GORHAM INDUSTRIAL PARK WEST CAMPUS

CYR DRIVE GORHAM, MAINE

PLANNING BOARD SUBMISSION
NOVEMBER 4, 2022

PRO-02

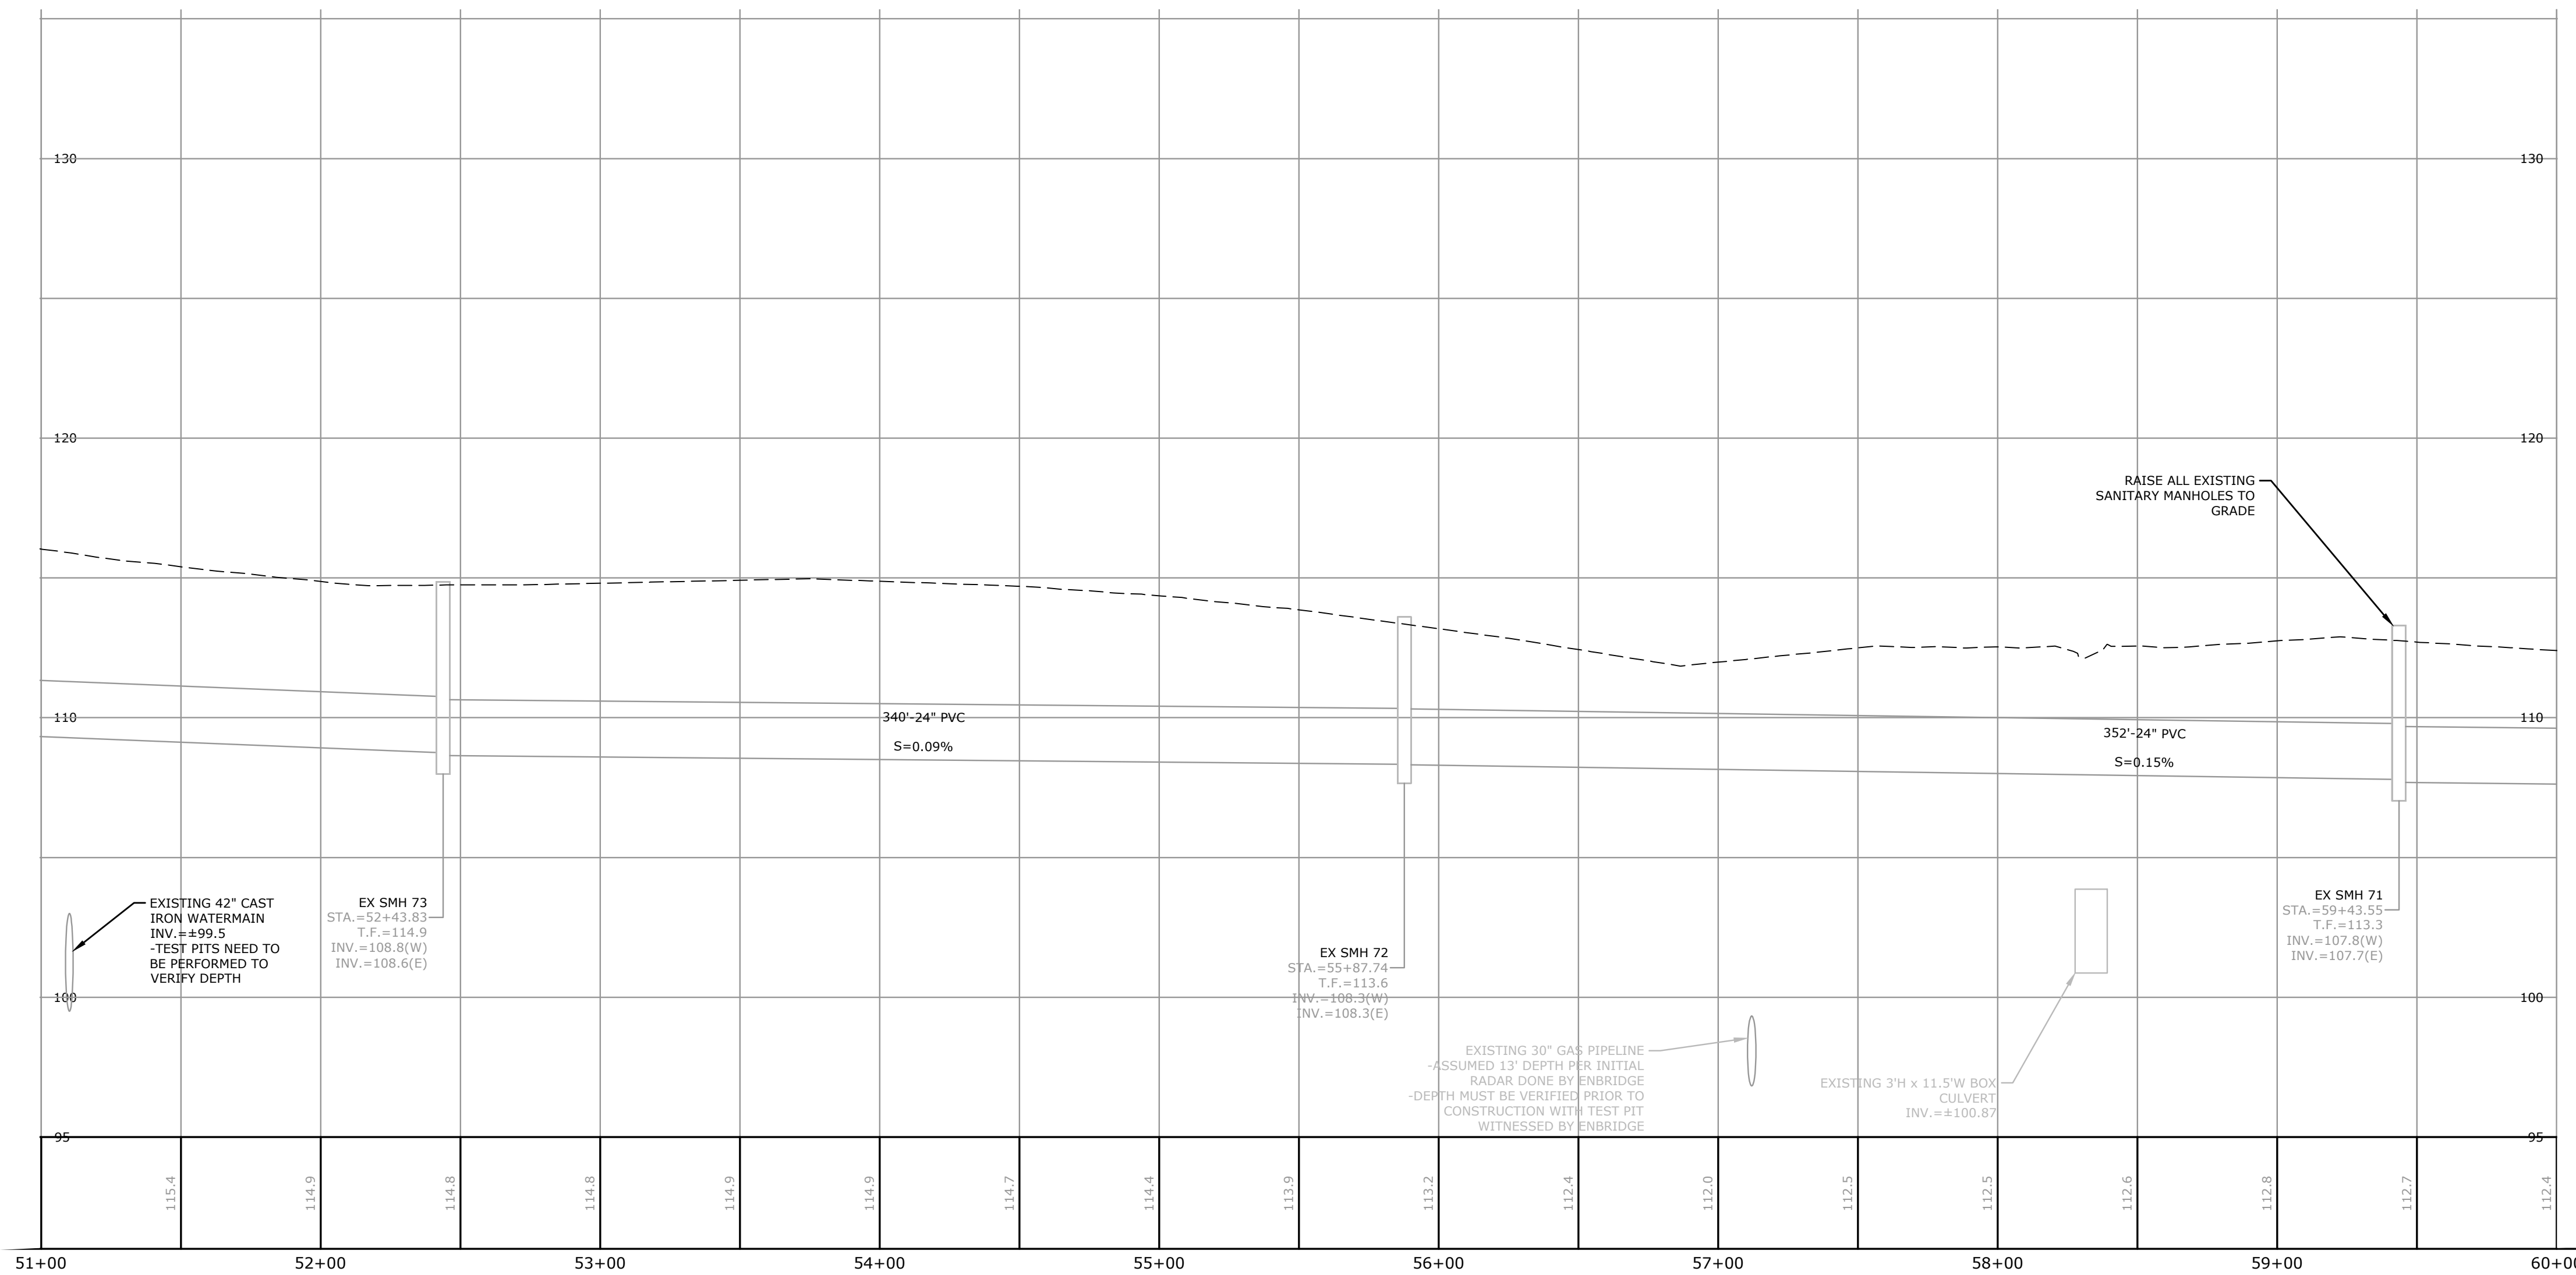
Applicant Response 2: Properly established vegetation along the roadside will establish gutter line flow of stormwater to the basins, in addition the roadside swale on the north side of road will collect runoff and there are two standpipes in the swale to collect/convey water to the piping system. The variable walk width occurs where the sidewalk tapers into the edge of the roadway at approximately STA. 49+46.8. The taper causes the width of the sidewalk to vary, but never less than 5 feet, as it approaches the eventual location of tie-in. This is shown in plan view on sheet PRO-02.
